# **SERVICE BULLETIN**

| PURPOSE: INFORMATION                             | ISSUE NO.: MSB-11E51-001 | DATE: 2011-01-20                 |              |
| SUBJECT: WIPER INSTALLED POSITION (LHD VEHICLES) |                          | <model><br/>(EUR/RUSSIA)</model> | <m y=""></m> |
| GROUP : EXTERIOR                                 |                          | OUTLANDER<br>(CW0W)              |              |

# >>B<< WIPER ARM AND BLADE ASSEMBLY INSTALLATION

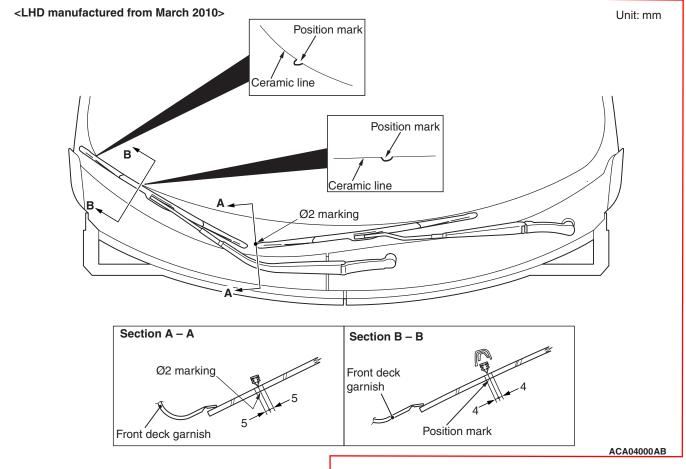
In order to improve the functionality, the installed position of wiper arm and blade assembly for LHD vehicles has been changed. According to this change, descriptions are changed in the applicable Workshop Manuals. This Service Bulletin contains the modified descriptions.

#### <Added>

Install the wiper arm and blade assembly at the specified positions.

(A): (Driver's side): $\phi$  2 marking $\pm$  5 mm (B): (Passenger's side) : Position mark  $\pm$  4 mm
